WORKHORSE CUSTOM CHASSIS SERVICE BULLETIN

BULLETIN NO: 51101-C

SUBJECT: Replacement of Bosch Service Brake Calipers

MODELS: All 2001 through 2011 Model Year W20, W21, W22, and W22D Motor Home Chassis Equipped with Bosch Brake Calipers

Remedy Bosch Brake Caliper Identification

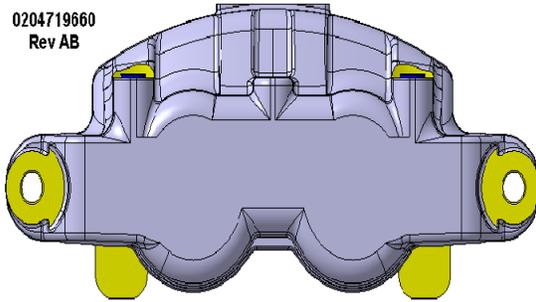
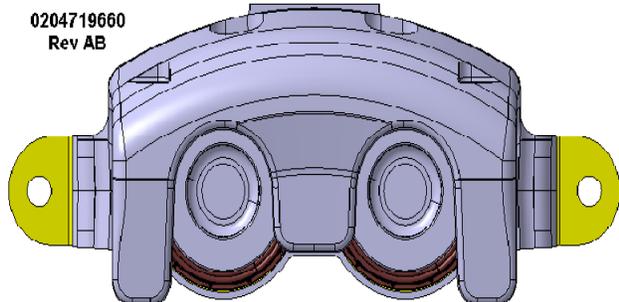
Part Number W8006753 (Caliper Kit)

The first date code was 0155A.

The pistons have the letter "B" molded in three locations at the bottom of the piston.

Caliper machined areas shown in yellow are not plated.

1.1 / C

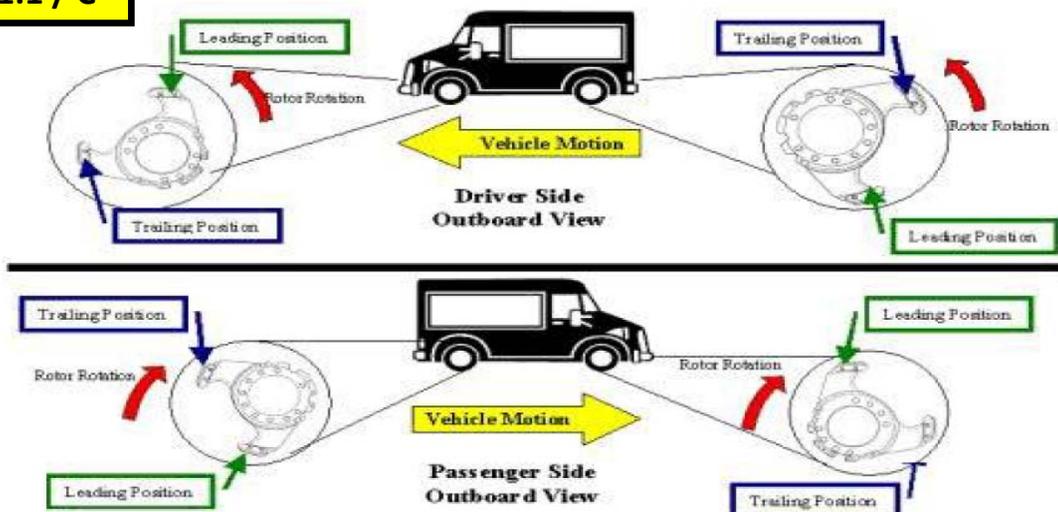
IMPORTANT: The ZOH-T leading bolt must be tightened first during the assembly process after both leading and trailing bolts are installed finger tight.

6. Torque the ZOH-T mounting bolts as follows:
 - a. Torque leading bolt to 93-107 lb-ft (126-145 N-m)
 - b. Torque trailing bolt to 93-107 lb-ft (126-145 N-m)
 - c. See Leading and Trailing bolt position illustration (1.1 / C)
7. Connect the brake hose fitting to the fluid inlet port on the caliper and torque to 14-17 lb-ft (20-24 N-m). (See illustration 1.0 / B)
8. Reconnect the brake hose retaining bracket to the caliper using the original bolt removed. (See illustration 1.0 / B)
9. Bleed brake system torque bleeder screw to 8-15 lb-ft. (10-20 N-m)
10. Install the tire and wheel assembly and torque the wheel lug nuts to 450-500 lb-ft.
11. Lower the vehicle.
